# UNITED STATES PATENT AND TRADEMARK OFFICE

APPLICATION NO.	FILING DATE	FIRST NAMED INVENTOR	ATTORNEY DOCKET NO.	CONFIRMATION NO.
10/574,881	04/06/2006	Martinus Jacobus Coenen	NL03 1229 US	1731
65913	7590	02/07/2008		
NXP, B.V. NXP INTELLECTUAL PROPERTY DEPARTMENT M/S41-SJ 1109 MCKAY DRIVE SAN JOSE, CA 95131			EXAMINER CLARK, JASMINE JHIHAN B	
			ART UNIT 2815	PAPER NUMBER
			NOTIFICATION DATE 02/07/2008	DELIVERY MODE ELECTRONIC

<b>Office Action Summary</b>	<b>Application No.</b> 10/574,881	<b>Applicant(s)</b> COENEN, MARTINUS JACOBUS	
	<b>Examiner</b> Jasmine J. Clark	<b>Art Unit</b> 2815

**FIG. 2**

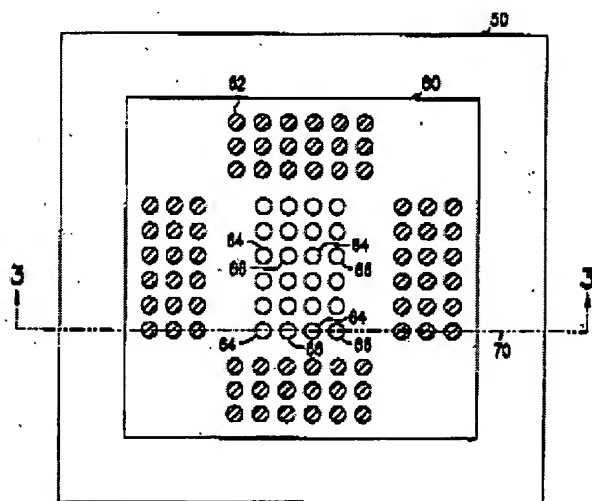
a semiconductor device providing with a plurality of bond pads, of which bond pads a first portion is defined for ground connection and a second portion is defined for voltage supply (see paras [0028], [0029] and [0030]) and a third portion is defined for signal transmission (see para [0033]), and a carrier substrate (50) comprising a layer of dielectric material (see para [0020]) and having a first side and an opposed second side, the first side and the opposed second side are each provided with an electrically conductive layer, on which first side bond pads are present corresponding to the bond pads of the semiconductor device, and on which second side contact pads (109, ie.,) for external coupling are provided, the contact pads and the bond pads being subdivided into a first, a second and a third portion corresponding to the portions of the

semiconductor device, the first and second portions of the bond pads being present laterally in an inner area (areas of solder balls 64 and 66 disposed) and the third portion (areas of solder balls 62 disposed) being present in an outer area around the inner area, wherein the semiconductor device is coupled to the carrier substrate in a flip-chip orientation, and the bond pads and the contact pads for voltage and ground connection ( $V_{cc}$  and  $V_{ss}$ ) are located correspondingly, so as to provide a direct path from the contact pads at the substrate to the corresponding bond pads of the semiconductor device, and the pads of the first and second portions (116, 121 and 125, for example) are arranged such that at least one direct dedicated to voltage supply connection acts as a coaxial center conductor.

Concerning claim 3 and 4, wherein the pads for ground and supply connections are arranged according to a chessboard pattern (see Fig. 2 above), and wherein a layer of dielectric material (81 and/or 95, i.e.,) (see paras [0033] and [0036]) extends from the first to the second side in the substrate.

FIG. 3

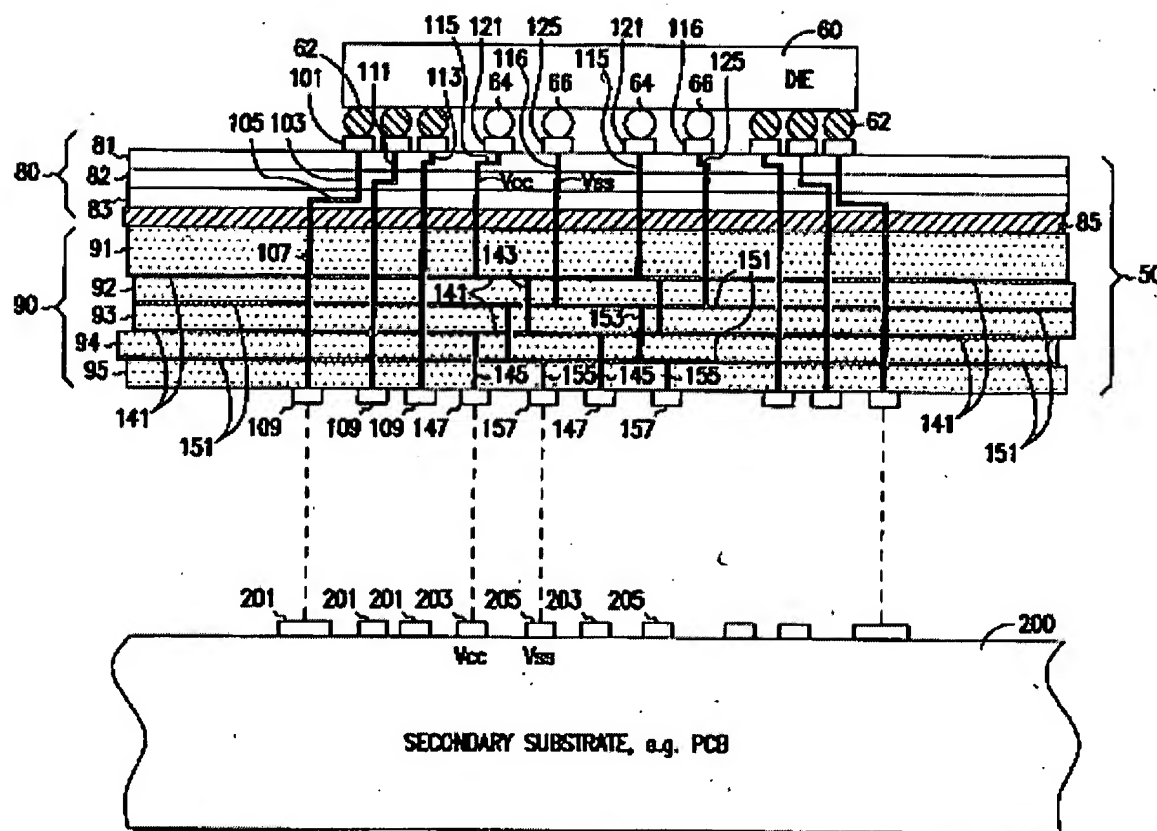
Concerning claims 5 and 6, an electronic device as claimed in claim 1, characterized in that the bond pads of the third portion and the corresponding contact pads (through 109, i.e.,) for external coupling are interconnected through; interconnects defined in the conductive layer on the first side of the carrier substrate (50), and vertical interconnects through the carrier substrate (50) which, in the case of perpendicular projection on the conductive layer on the second side, have a substantial overlap with the contact pads for signal transmission (at least at an internal region of the third portion, see Fig. 3 above). Furthermore, an electronic device as claimed in claim 5,

characterized in that a ground plane ( $V_{cc}$  and  $V_{ss}$ ) is defined in the conductive layer on the second side (i.e., 147 and 157) of the carrier substrate (50), and the mutual distance between the interconnects and the dielectric thickness of the carrier substrate are chosen such that the interconnects have transmission line characteristics. For the reason that the limitations of claim 10 are similar to claim 1, please see the above discussion.
